Emissions Recall

Code: 26M4

REVISION

Subject	Catalyst															
Release Date	September 05, 2020															
REVISION SUMMARY	<ul style="list-style-type: none">Updated claiming instructions and part information with Criteria M1 information.Updated claiming and work instructions to include rivet (N -038-549-4) for the noise insulation. Due to a change in the repair manual, this rivet is now a mandatory replacement part.Updated work instructions to include a caution about working with exhaust fasteners.															
Affected Vehicles

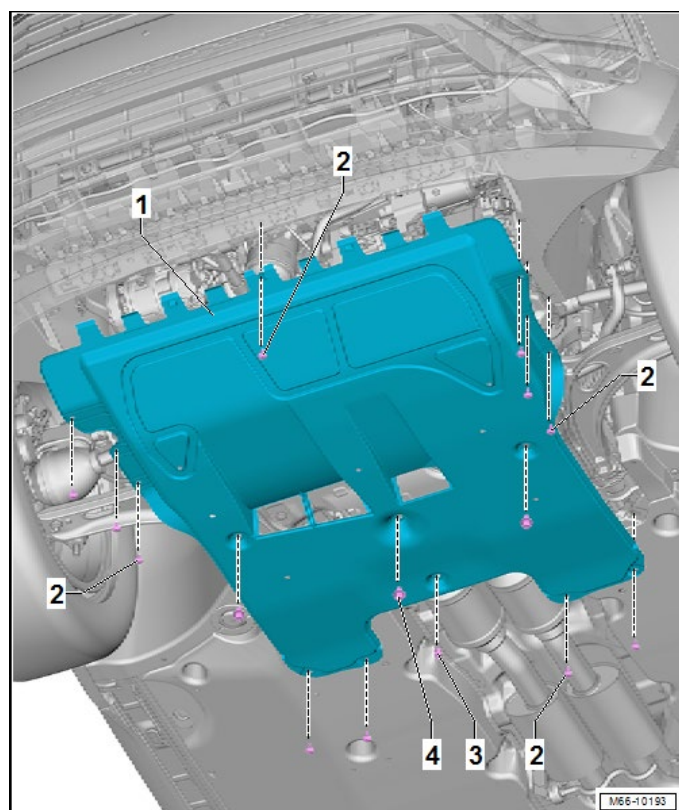
- A new expanding rivet <3> must be installed when reinstalling the noise insulation.

This rivet is required to prevent noise and to prevent debris from building up on the top of the noise insulation.

Part Number	Part Description
N -038-549-4	Expanding rivet
